Office Action Summary

10/771,056

DETAILED ACTION

Reproduced from U.S. Patent No. 6,148,579

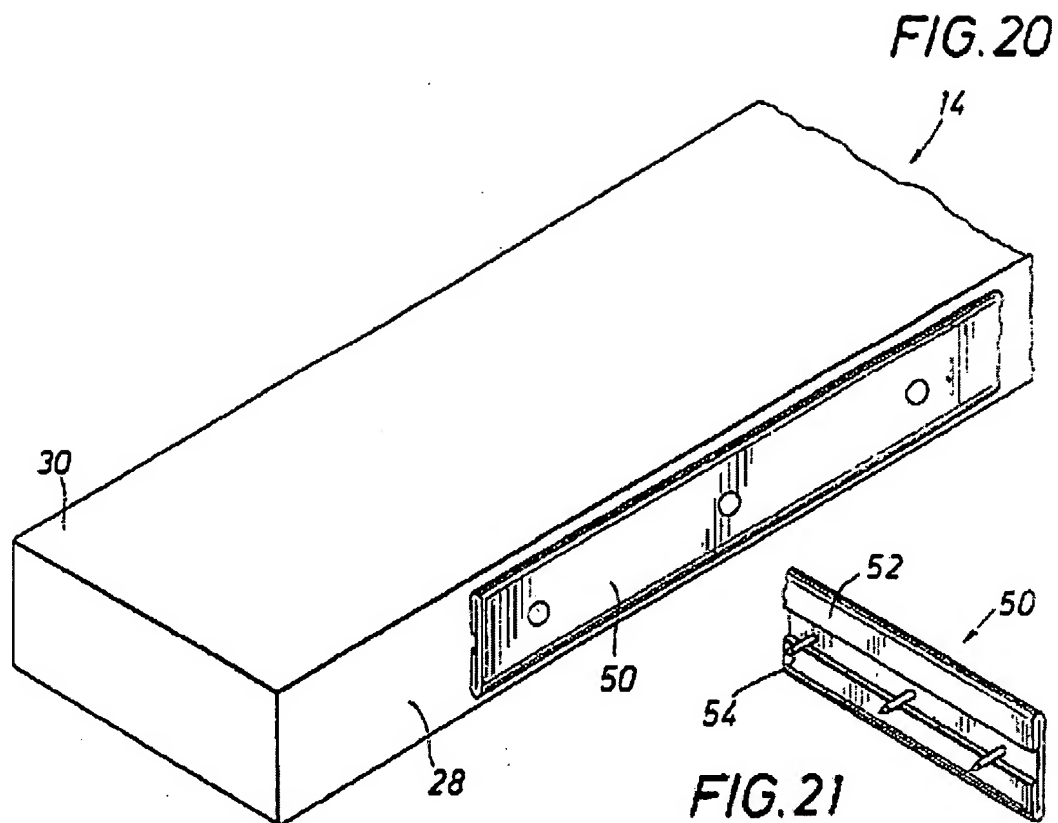
4. Claims 1 and 3-6 are rejected under 35 U.S.C. 102(b) as being anticipated by Rolf (U.S. Patent No. 6,148,579).
5. Regarding claim 1, Rolf discloses a truss having all of applicant's claimed structure, including:

- a. "A structural truss comprising: a plurality of structural members...defining a plane..." ("floor truss" 4, Figure 33).

- b. "...a web including at least one web member extending between two structural members within said plane..." ("chords" 18 and "interior web member" 14, Figure 33).
- c. "...the web member having first side portions...within said plane;..." ("web member" 14, Figure 20).

FIG. 4

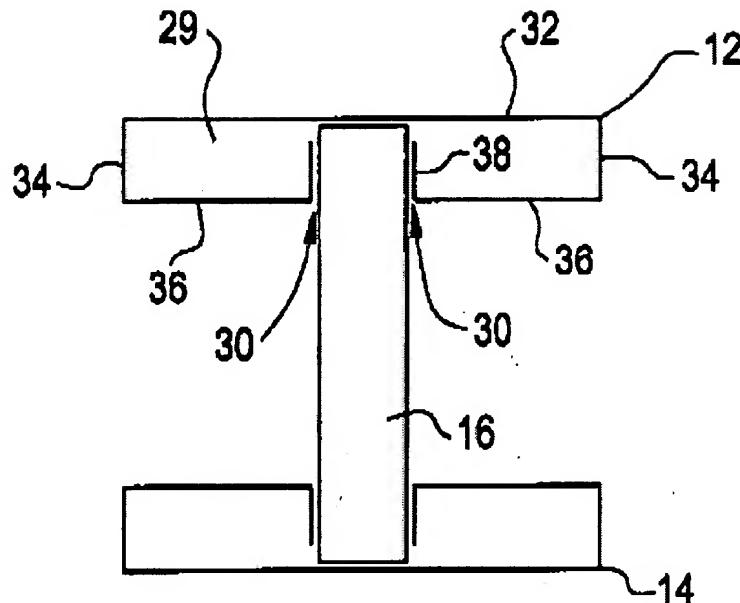
- c. Ehrenkrantz discloses a metal reinforcing flange having a flat base ("outwardly facing portion" 32, Figure 4), a pair of opposite side walls extending from the base generally transverse to the base ("pair of opposed side portions depending from the outwardly facing portion" 34, Figure 4) [claim 7], inwardly turned ends ("a pair of inwardly facing portions depending from respective side portions" 36, Figure 4) [claim 8], and ends of the side walls which turn about 180 degrees ("support lip" 38, Figure 4) [claim 9]. The combined use of wood web members and metal braces such as those disclosed in Ehrenkrantz adds strength, as taught by Melland.

Reproduced from U.S. Patent No. 6,148,579

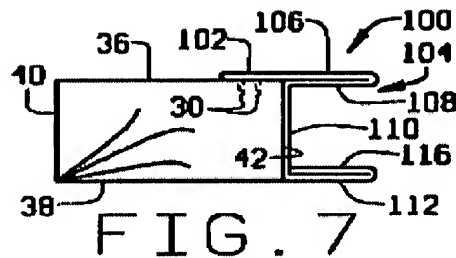
- d. "...a brace secured to the web member..., the brace engaging the web member at one of said lateral sides;..." ("side brace" 50, Figure 20).
- e. "at least one fastener securing the brace to the web member, the fastener penetrating the web member at one of said lateral sides;..." ("nails or the like" 54, Figure 21).
- f. "wherein said front and back sides of the member remain free from fasteners" (Figure 20).

6. Regarding claim 3, Rolf discloses rectangular web members ("web member" 14, Figure 20).
7. Regarding claim 4, Rolf discloses a brace with fastener holes ("side brace" 50, Figure 20).
8. Regarding claim 5, Rolf discloses non-integral fasteners ("nails or the like" 54, Figure 21).
9. Regarding claim 6, Rolf discloses a brace entirely within the thickness confines of the web member (Figure 20). The "side brace" (50) is clearly within the confines of the lateral side of "web member" (14).
